Field Service Bulletin No. 18

**PN 90402 SBE 45 Power, Navigation, & Remote Temperature Interface Box
 Wiring Error**

DC In Wiring Detail
 (paper inserted to clearly show wiring to *DC In*):
Correct wiring is black wire on left, red wire on right

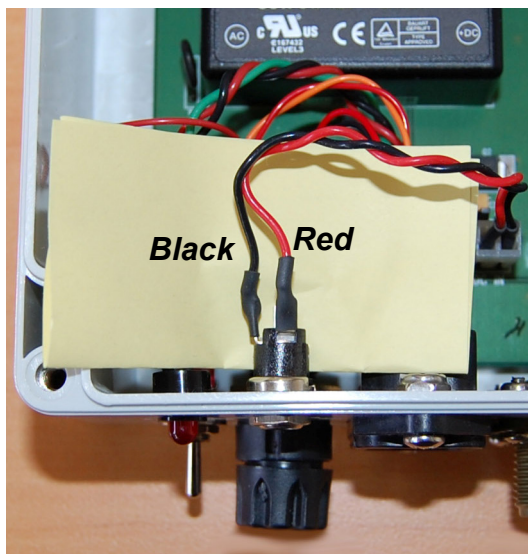
For the specified serial numbers, the wiring terminating at the *DC In* connector is reversed. Consequently, if using DC power for input to the Interface Box, the Interface Box will not function when you turn the *Power On/Off* switch to the On position.

- Switch the red and black wires terminating at the *DC In* connector. The correct wiring is shown below.
- **OR**
- Return the Interface Box to Sea-Bird. Sea-Bird will correct the wiring, and return it to you at no charge.
